Architectural Review Board Staff Report

Project Type:	Site Development Section Plan
Meeting Date:	April 14, 2022
From:	Mike Knight, Assistant City Planner <i>gmk</i>
Location:	A 0.8 acre tract of land located southeast of the intersection of Parkview Terrace and Wildhorse Lake Blvd.
Description:	<u>Wildhorse Village, Lot 2B (Wildhorse Village Condos) SDSP:</u> A Site Development Section Plan, Landscape Plan, Lighting Plan, Architectural Elevations and Architect's Statement of Design for a 0.8 acre tract of land zoned "PC&R" – Planned Commercial and Residence District located southeast of the intersection of Parkview Terrace and Wildhorse Lake Blvd.

COVER SHEET - ARB SUBMISSION
 WILDHORSE VILLAGE CONDOS
 CHESTERFIELD, MO
CRG Acquisition, LLC

Figure 4: Color Site Plan

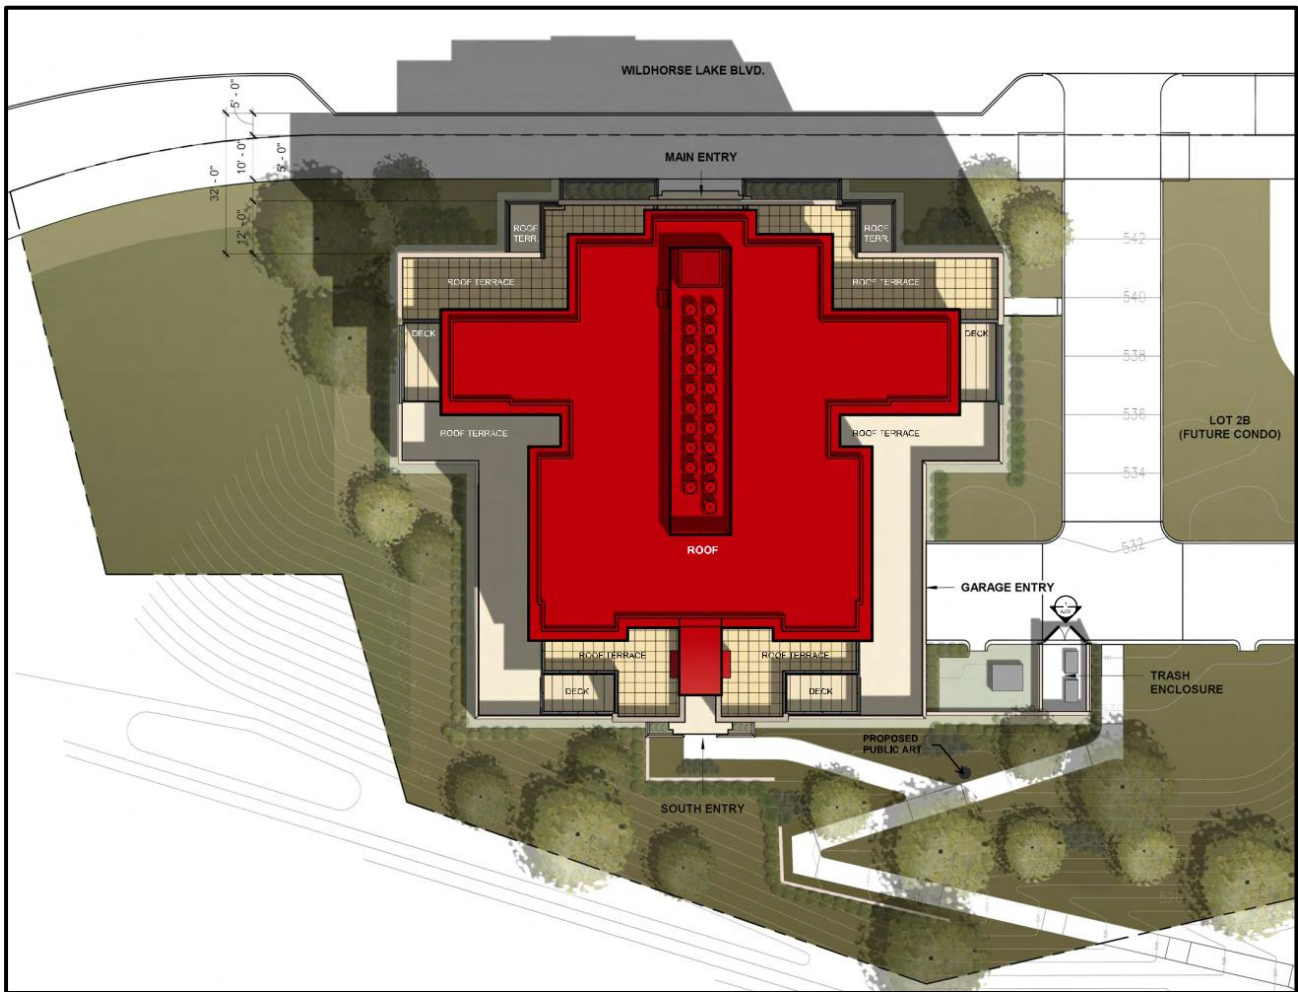
The site is accessed by one curb cut off Wildhorse Lake Blvd and will be a shared drive with a future mirrored condo building east of the site. All vehicular access will utilize this drive for tenant parking, loading and trash. Internal pedestrian paths connect to the large pedestrian paths of the overall Wildhorse Village development. A color Site Development Section Plan (Figure 4) was provided in this packet depicting the access and circulation locations.

Figure 5: Building Materials

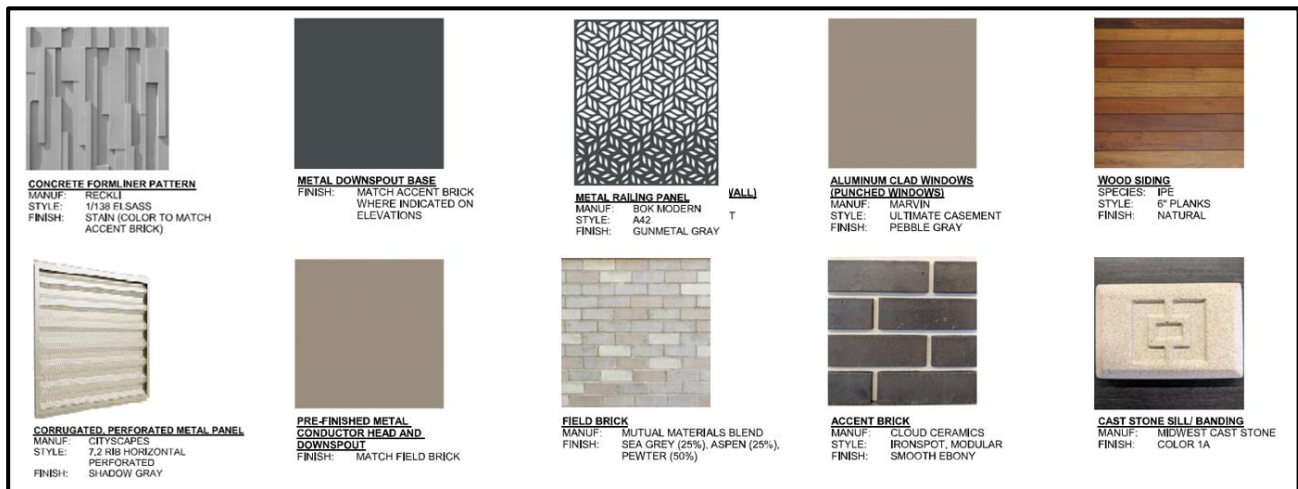
The building is primarily two different colors of brick. Accents of wood siding are provided on all 4 elevations. An exposed concrete form-liner pattern stained to match the accent brick is seen on the east, west, and south elevations. Below is an image of the manufacturer, style, and color of the building materials.

ARCHITECT'S STATEMENT
WILDHORSE VILLAGE CONDOS
CHESTERFIELD, MO
CRG Acquisition, LLC

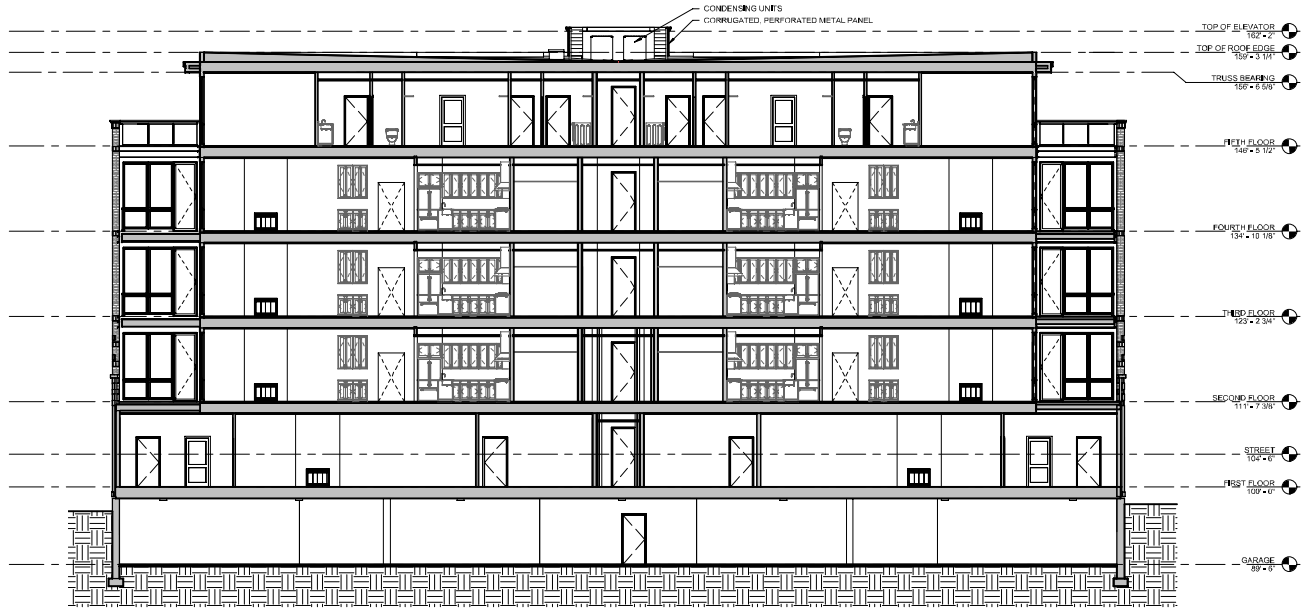
A modification is being requested in regards to the rooftop mechanical screening requirement. Ordinance 3161 states, "rooftop mechanical equipment shall be permitted on roof within architecturally designed, fully enclosed penthouses that complement the building design". The applicant is proposing to screen the rooftop equipment on all visible sides with materials that are an integral part of the architecture. A full narrative of the modification request is included in this packet. The Architectural Review Board's recommendation on the requested modification will be provided to the Planning Commission.

We request a modification to Section IG.5 of Ordinance No. 3161, which states: "rooftop mechanical equipment shall be permitted on roofs within architecturally designed, fully enclosed penthouses that complement the building design." We are proposing to enclose the elevator overrun and rooftop equipment with a cohesive material with consistent top trim that is an integral part of the architecture and will not visually weaken the design of the structure, per UDC Section 405.04.010. The top of the enclosure will remain open for free ventilation.

Therefore, we are showing all units together over the central corridor. A screen wall will encompass the equipment as well as the elevator overrun to provide a singular, seamless surround that invokes the continuation of the corridor spine up through the roof. In order to accomplish this, we are proposing a metal panel screen of the same warm grey color and horizontal aesthetic as the other trim on the building at the roof level. We feel this solution provides the best aesthetic of simply another stepped back building level continuing with the theme below.
